From: Ben Stone RIBA <
Sent: Wednesday, December 6, 2023 12:56 PM
To: Victoria Flintoff
Cc: Ashley Line < >; Robert Coop
Subject: Re: Thorpe Hall NYM/2023/0417

Please find attached an updated version of the drawing **ref: W5001 PL30 08BA3 - Greenhouse Proposed Elevations**

Job: **Thorpe Hall**
Address: Middlewood Ln, Fylingthorpe, Whitby YO22 4TT

Drawing: **Greenhouse Proposed Elevations**

Photographs of field entrance gate:

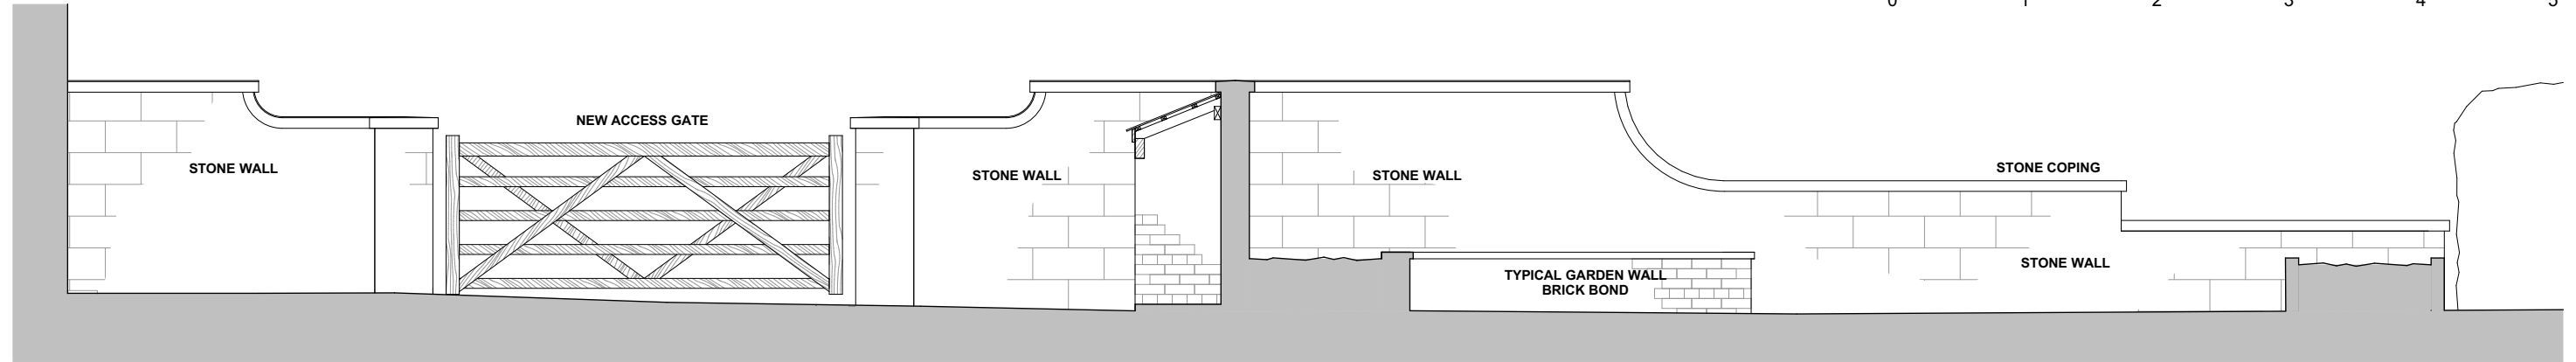
The access gate into the field is only for intermittent use not as a permanent track. We are not saying there is an existing track. There is an existing field access from the cinder track and there are existing gateways through the fields that comprise the land parcel associated with Thorpe Hall. Photograph of the track entrance to follow.

The existing cinder track entrance is only to be used (including the existing use) to relieve the main entrance for a short period whilst this period of construction is undertaken. There will be no permanent track formed only temporary ground protection if required.

In the future the access from the cider track is not intended to be any different to the situation pre this application. i.e a field access.
